SERVICE BULLETIN

POWER PLANT - ENGINE - EEC HARNESS FAN - REVISED CLIPPING OF LOOMS B AND D ADJACENT TO FUEL COOLED OIL COOLER - CATEGORY CODE 6 - MOD.ENG-71-0156

V2500-ENG-71-0156

Location of clipping points 2405 and 2407
Fig.1

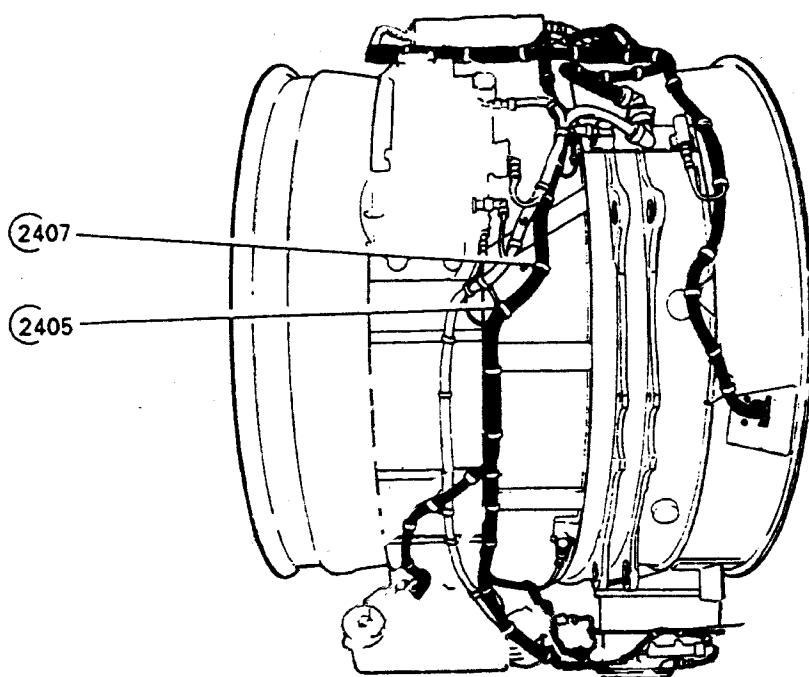
- (1) Find harness looms 'B' and 'D'. Refer to Figures 1 and 2.
- (2) Disassemble clipping point CP2405, remove 4W0112 bolt, 4W0043 clipnut, UP10480 spacer and AS62515 clamp. Refer to Figures 2 and 4.

Part view on left hand side of engine - Before alteration
Fig.2

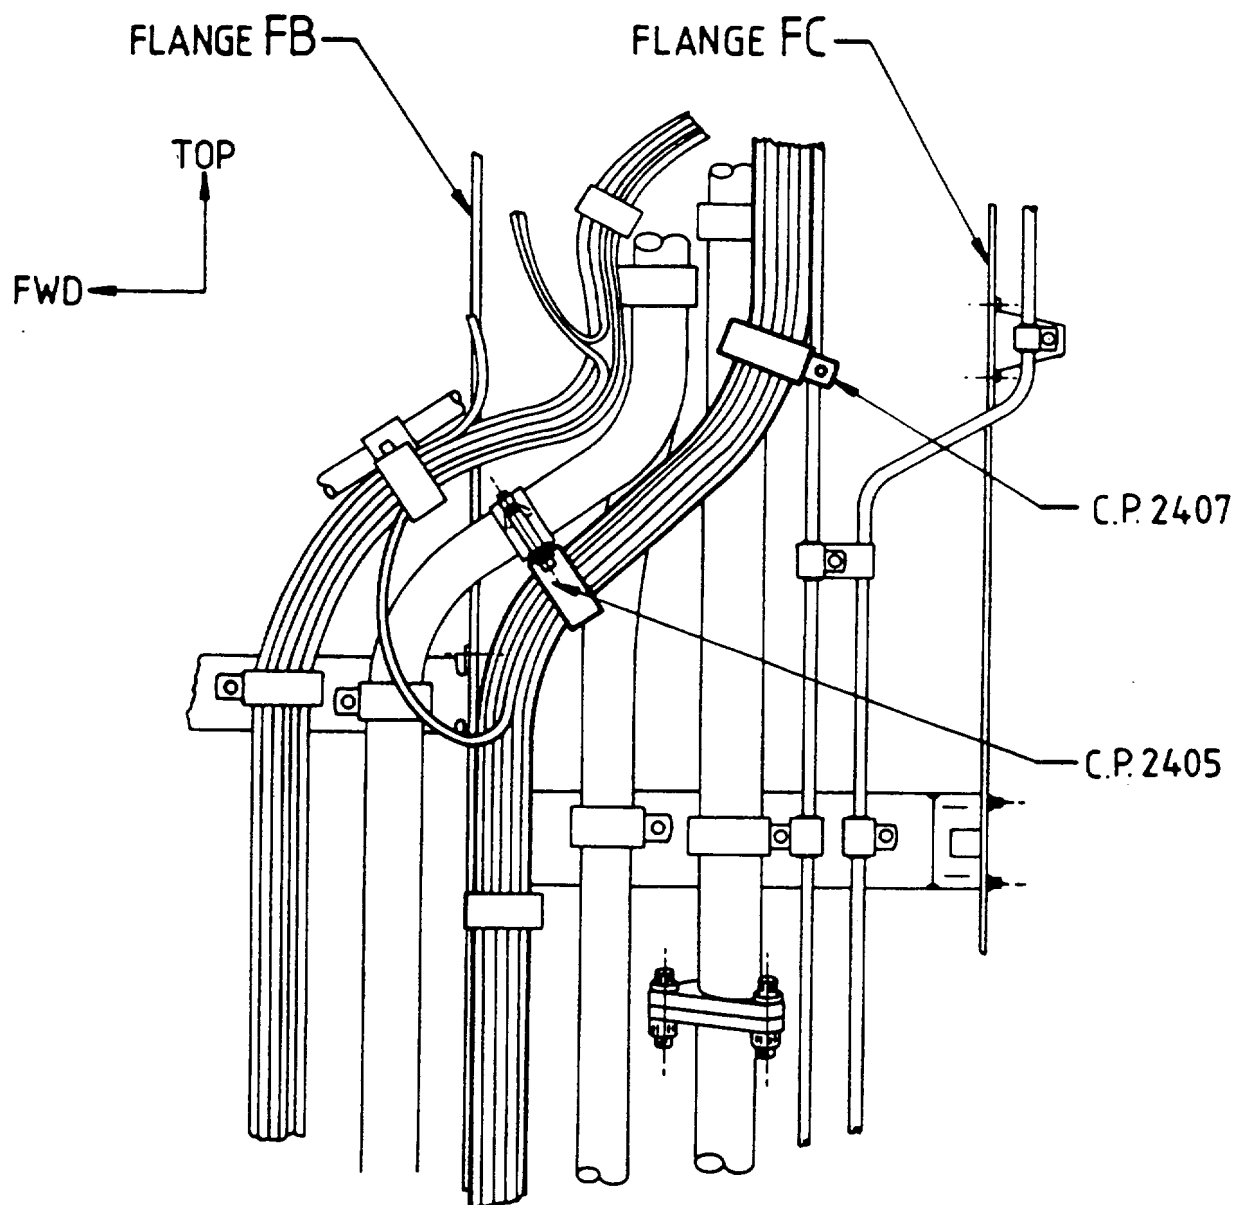
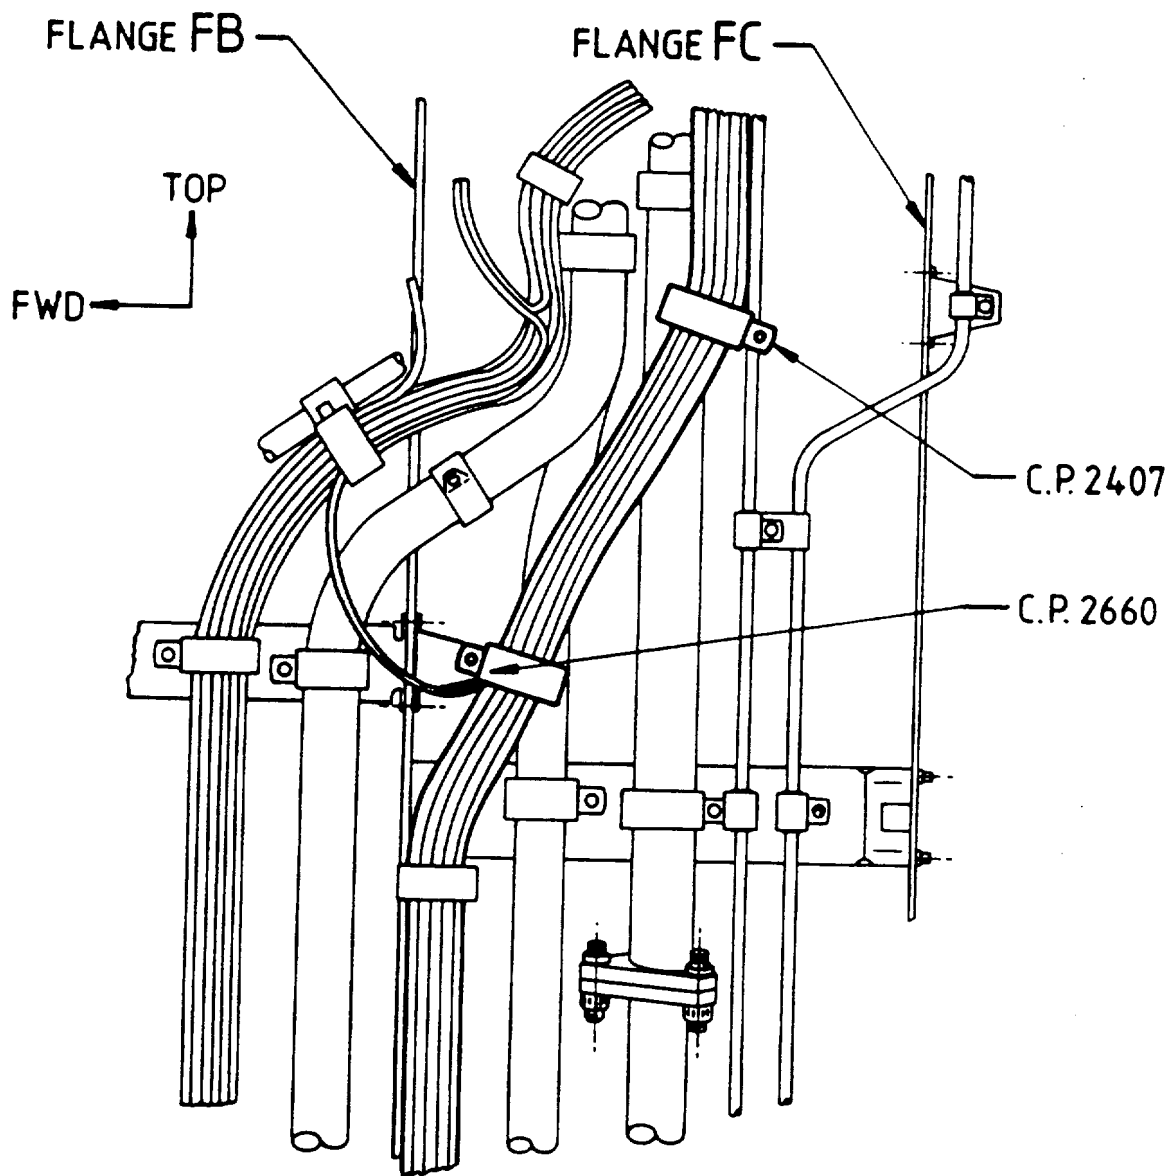
- (1) Clipping point 2045 is deleted and the harness previously clipped at this point is now transferred to new clipping point 2660 on flange FB along with new bracket at hole positions 61 and 62.
- (2) Clipping point 2407 is amended by adding an additional spacer and a longer bolt.

- (3) Disassemble clipping point CP2407, remove AS20908 bolt and 4W0001 nut. Refer to Figures 2 and 5.
- (4) Remove the AS21010 bolts (2 off) and 4W0002 nuts (2 off) at hole position numbers 61 and 62 on flange face 'B'. Refer to figures 3 and 6.

- (5) Install the new 6A4886 bracket to flange face 'FB' at hole position numbers 61 and 62 using the new AS21011 bolts (2 off) and existing 4W0002 nuts (2 off). Torque the bolts to 85 to 105 lbfin (10 to 12 Nm). Refer to figures 3 and 6.

- (6) At new clipping point CP2660 install harness looms 'B' and 'D' into new AS62518 clamp. Assemble new clipping point to 6A4886 bracket and using new 4W0103 bolt, new AS62518 clamp and new 4W0043 clipnut. Refer to Figures 3 and 6.

- (7) At existing clipping point CP2407, assemble revised clipping point using new 4W0110 bolt, existing AS62518 clamp, new UP10479 spacer, existing 6A5029 tube and existing 4W0001 nut. Refer to Figures 3 and 5.
